Why is the development team resubmitting the overall SDD?

Special Development District (SDD) Summary: September 13, 2016

Special Development District (SDD)
 Summary: November 21, 2016 Resubmittal

SDD Amendment Modifications

Neighborhood design considerations: stepped massing along Lyle

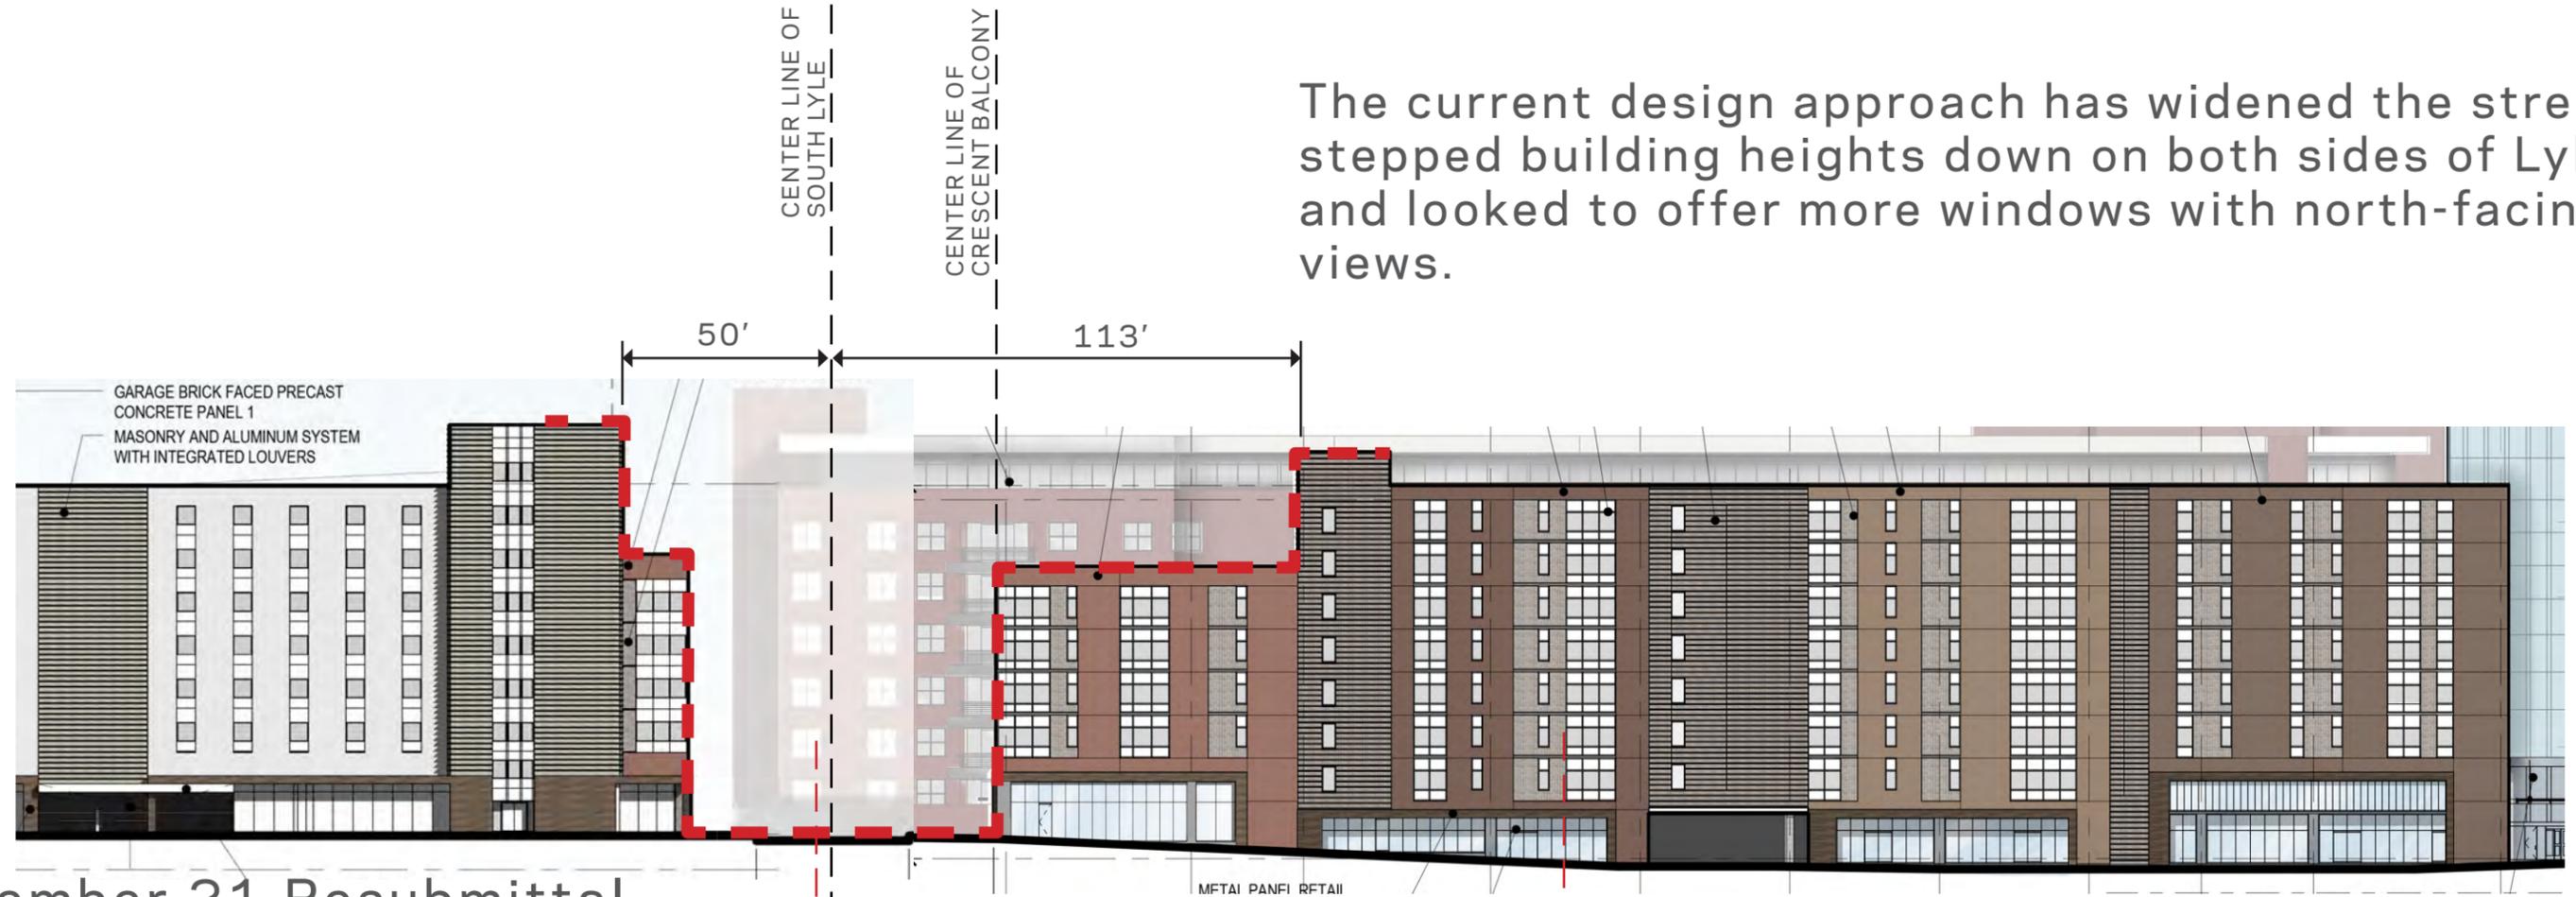
The current design approach has widened the street, stepped building heights down on both sides of Lyle, and looked to offer more windows with north-facing views.
